Field campaign

Topic	New Continental GTC - Header flap - Cord replacement (SC21/24)
Market area	Russische Föderation (5RU),Australia E04 Bentley rest Asia and Australia (6E04),China 796 VW Import Comp. Ltd (Vico), Beijing (6796),Germany E02 Bentley rest Europe (6E02),Japan E03 Bentley Japan (6E03),United Arab Emirates E06 Bentley Middle East and Africa (6E06),United Kingdom E01 Bentley UK (6E01),United States E05 Bentley USA and rest America (6E05)
Brand	Bentley
Transaction No.	2063926/1
Campaign number	EC06
Note	
Type	
US code

New Continental GTC

Figure 4

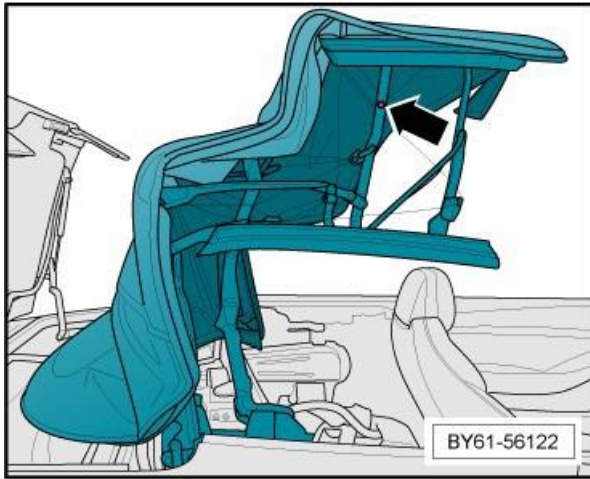
2) Referring to Figure 4 - Using a 3.4 mm drill bit, remove the rivet head from the second upright linkage

Figure 7

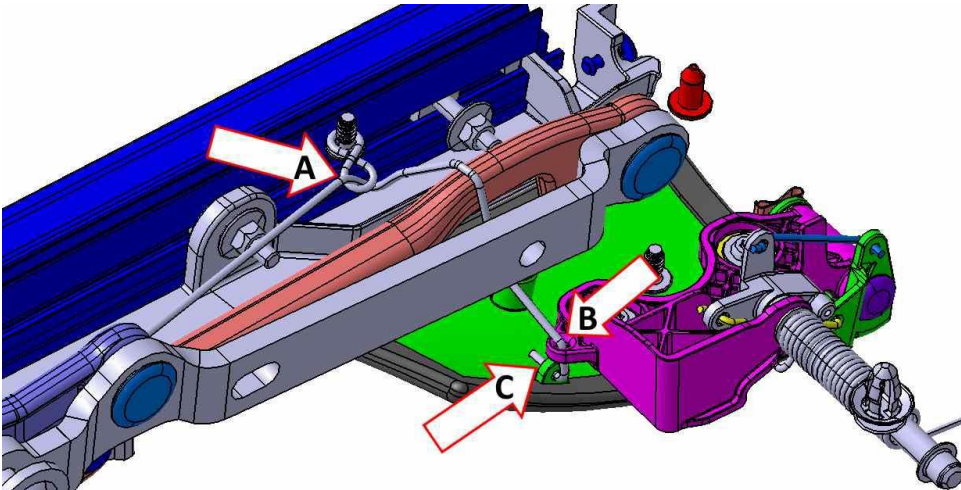
5) Referring to Figure 7 - Note the routing of the cord to aid installation - Remove the cord as follows:

- Pull/thread the cord out through the primary redirector (A)
- Pull/thread the cord out through the secondary redirector (B)
- Pull/thread the cord out through the flap eyelet (C)

Figure 9

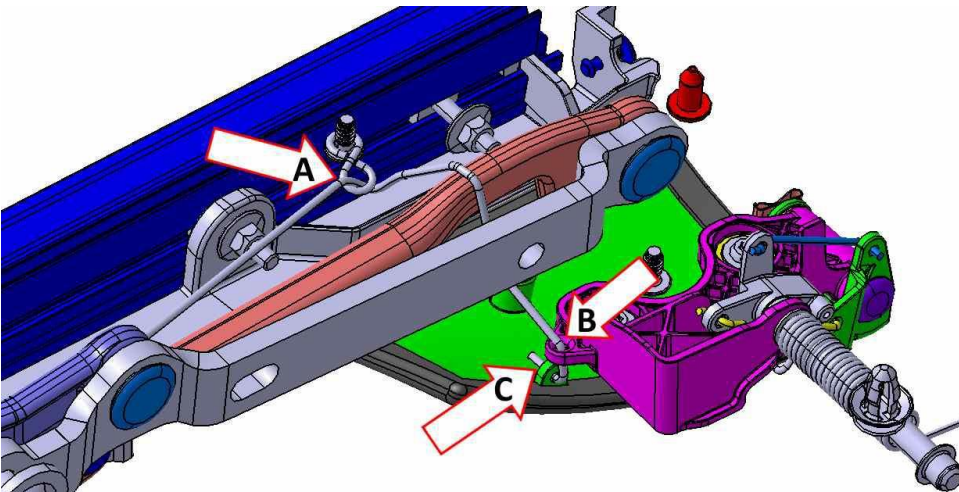
1) Referring to Figure 9

- Feed the new cord through the primary redirector (A)
- Feed the new cord through the secondary redirector (B)
- Feed the new cord through the flap eyelet (C)

Figure 10

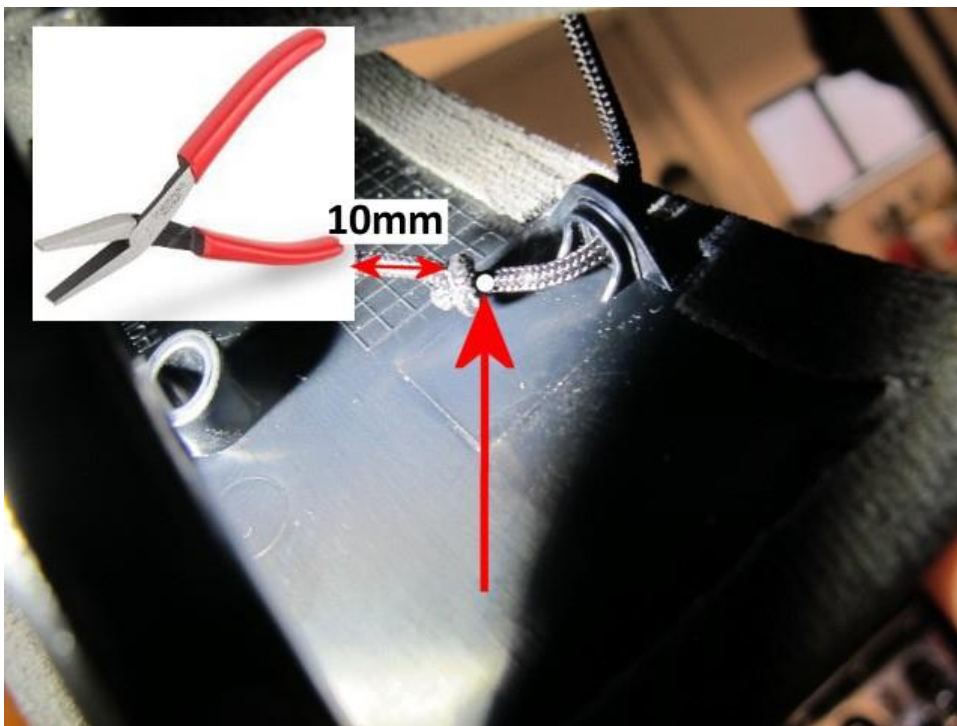
2) Referring to Figure 10 - Using suitable flat-nose pliers, tighten the knot by pulling the cord

▪
 The knot (once securely tied) must be below the white dot (Figure 10)

- With extreme care to ensure no damage is caused to any trim or components - Use a sharp blade (e.g Stanley knife) or very sharp trim scissors (to minimise fraying) - Cut the cord at the location shown, leaving 10mm below the knot

Figure 6

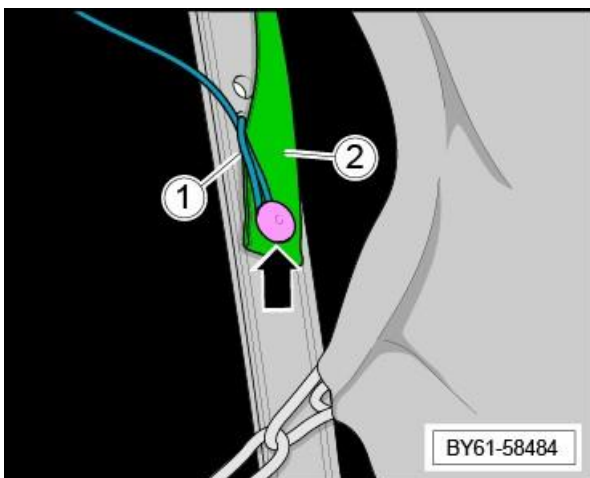
- Referring to Figure 11 - When riveting the cord -1- and tape -2- to the second upright linkage, use the rivet provided within the kit (Arrow)
- Place the cord loop -1- and the tape -2- onto the rivet, and ensure that the cord is in an upright position before riveting

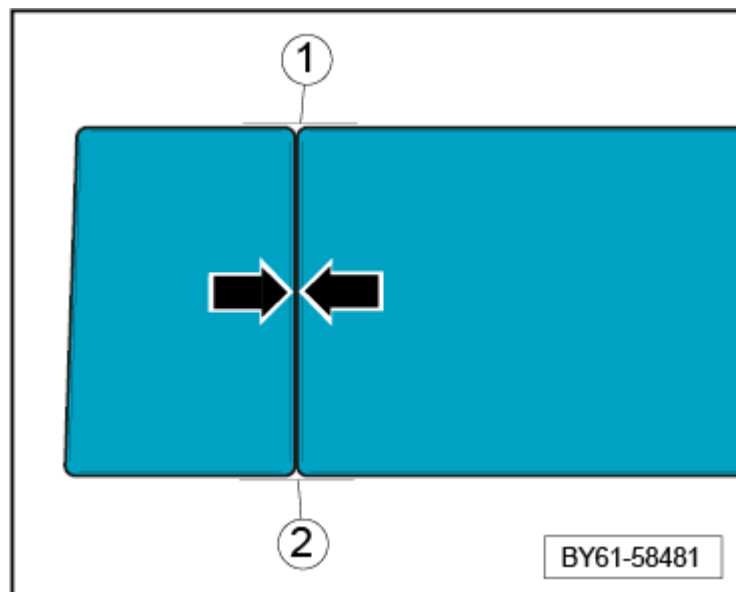
- Align the flap assembly to the header trim panel, ensuring that the edges **-1-** of the two panels align, and that the gap **-arrowed-** between the two panels is 2.5mm (+0.5/-1.5) and consistent along the whole length .

Misalignment of the panels can cause damage to both the header trim panel and the header trim panel flap assembly.
